**MEMORANDUM**

**TO:** CPEO  
**FROM:** Peter Strauss  
**DATE:** March 22, 2017  
**SUBJ:** **Hangars 1, 2, and 3 at Moffett Field**

**Hangars 2 and 3 are shown on the right (southern) edge of Site 26.**

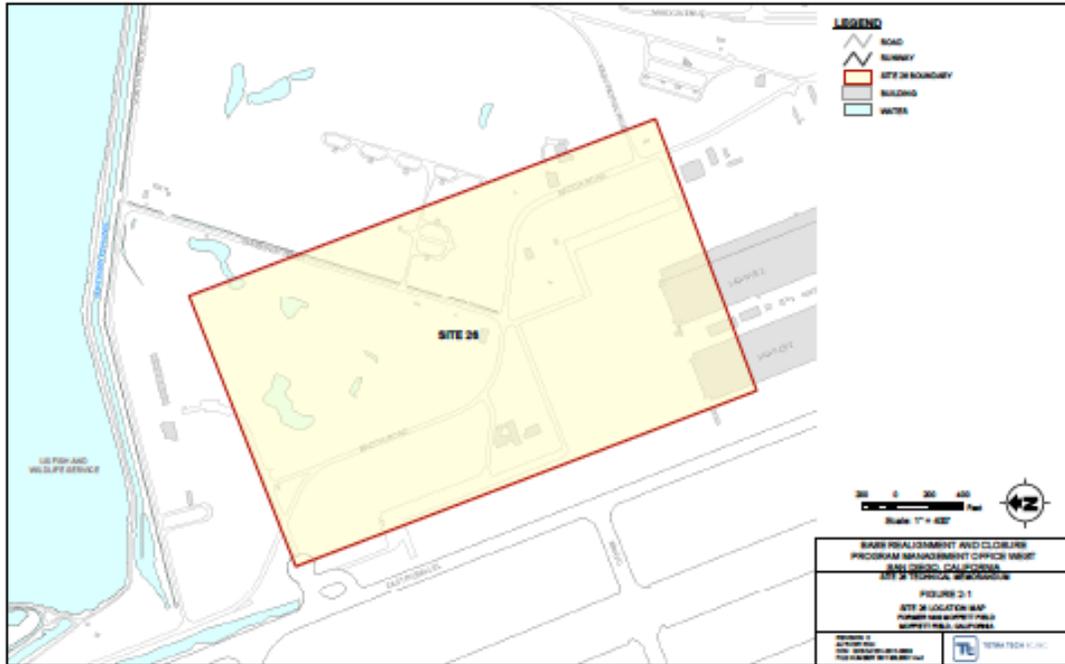
The 1996 OU5 Record of Decision (ROD) selected remedies for the chlorinated volatile organic compounds (CVOCs) in groundwater on the east side of Moffett (Site 26). The Site 26 CVOC groundwater plume begins at the northeastern corner of Hangar 3 and migrates northward, away from the two hangars. Some of the CVOCs released into groundwater from the Site 7 are addressed as part of the remedy for Site 26.
